**ELECTRICAL SAFETY FOLLOW UP INSPECTION REPORT (1<sup>ST</sup>)**

<b>Factory Name</b>	Space Sweater Ltd (Jogitala)				<b>Note:</b>	
<b>Address</b>	Shi-145/1, Jogitola, Joydebpur,					
<b>FACTORY ID</b>	<b>23383</b>	<b>ELECTRICAL SAFETY INSPECTION DATES</b>				
<b>Initial Inspection Date</b>	02-Jul-2018	Date of 5 <sup>th</sup> Follow Up		Date of 11 <sup>th</sup> Follow Up	<b>Other Factory:</b> ----- ----- ----- -----	
<b>Report Received Date</b>		Date of 6 <sup>th</sup> Follow Up		Date of 12 <sup>th</sup> Follow Up		
Date of 1 <sup>st</sup> Follow Up	15-May-2019	Date of 7 <sup>th</sup> Follow Up		Date of 13 <sup>th</sup> Follow Up		
Date of 2 <sup>nd</sup> Follow Up		Date of 8 <sup>th</sup> Follow Up		Date of 14 <sup>th</sup> Follow Up		
Date of 3 <sup>rd</sup> Follow Up		Date of 9 <sup>th</sup> Follow Up		Date of 15 <sup>th</sup> Follow Up		
Date of 4 <sup>th</sup> Follow Up		Date of 10 <sup>th</sup> Follow Up		Date of 16 <sup>th</sup> Follow Up		
<b>Inspected by</b>		<b>Abu Zobair</b>

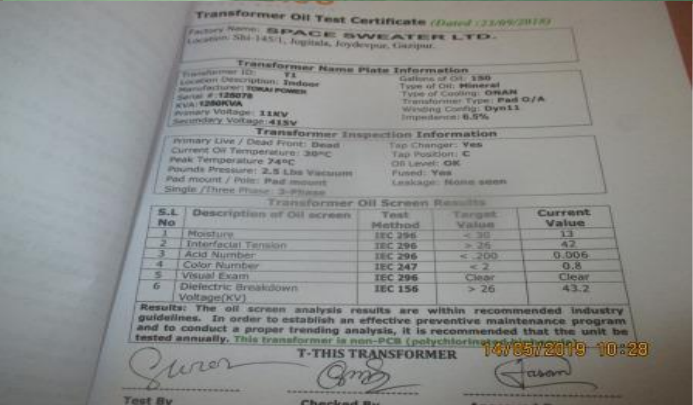
Item No	Accord Inspection Observation	Accord Action Plan (Recommendation)	Accord Time line (given in report)	Comments from Accord (After Physical Inspection)	Final Timeline (Approved timeline)	Final Action Plan (Factory)	Progress Status (On the date of inspection)	Pictorial Evidence
1	Electrical Single Line Diagram (SLD) is unavailable in the factory	As built Electrical SLD must be prepared; it must have factory's whole electrical installation information	2 MONTHS	<b>On 14/05/2019:</b> Not corrected. Factory is working on this issue.	28-Oct-2018	We are working to prepare single line diagram (SLD). After completion the SLD we will submit to Accord for review.	In Progress	
2	Lightning Protection System (LPS) installation is not completed.	Factory has to design Lightning Protection System (LPS) for the whole factory (where the Risk index is more than 40). Once LPS is designed properly, installation must be done accordingly.	3 MONTHS	<b>On 14/05/2019:</b> Corrected.	28-Nov-2018	Installation of Lighting Protection System is in progress . 70 % work already completed. Remaining work will be completed within given time frame.	Corrected

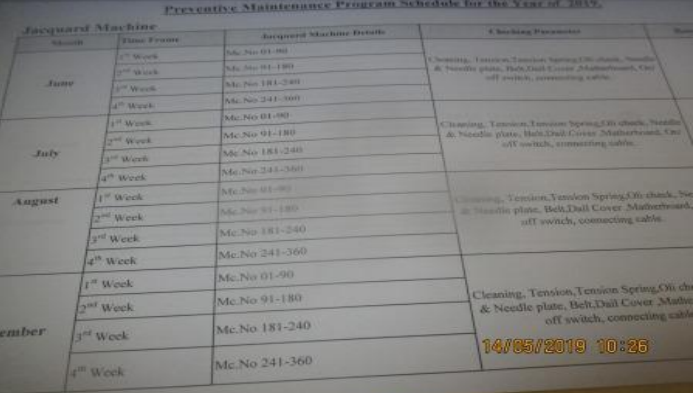
Item No	Accord Inspection Observation	Accord Action Plan (Recommendation)	Accord Time line (given in report)	Comments from Accord (After Physical Inspection)	Final Timeline (Approved timeline)	Final Action Plan (Factory)	Progress Status (On the date of inspection)	Pictorial Evidence
3	Transformer Oil Test (dielectric strength test) report is unavailable	Transformer oil test (dielectric strength test for oil) shall be done once in a year.	2 MONTHS	<b>On 14/05/2019:</b> Corrected.	28-Oct-2018	We will do the test of transformer oil according to Accord guide line.	Corrected	
4	There is no programmed schedule for periodical inspection & testing of electrical equipment.	An electrical maintenance program shall be prepared which will include inspections and testing of the electrical systems (preventive and proactive)	2 MONTHS	<b>On 14/05/2019:</b> Corrected.	28-Oct-2018	We are working to maintain schedule of inspection & testing of electrical equipments/installations according to Accord guide line.	Corrected

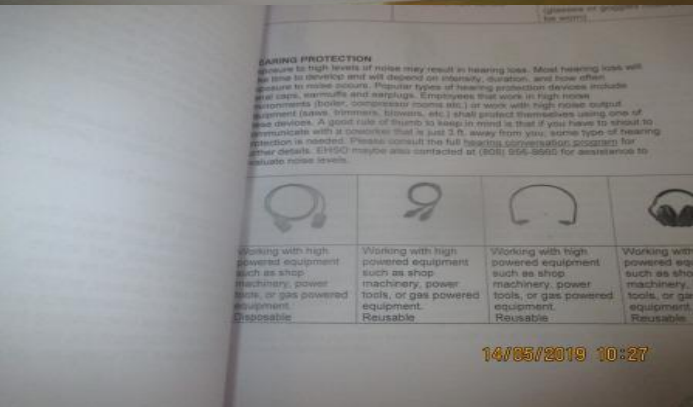
5	No LOTO (Lock-Out-Tag-Out) policy is introduced for safety of the personnel during any kind of maintenance work	Need to introduce and implement LOTO policy with LOTO (Lock-Out-Tag-Out) device instead of any other means to ensure safety of the personnel during any maintenance. Need to keep all using records.	2 MONTHS	<b>On 14/05/2019:</b> Corrected.	28-Oct-2018	We already trained electrical personnel about Lock Out & Tag Out policy but log out tag out device not available in the factory. Factory will purchase the devices & it will be available in factory within given time line.	Corrected
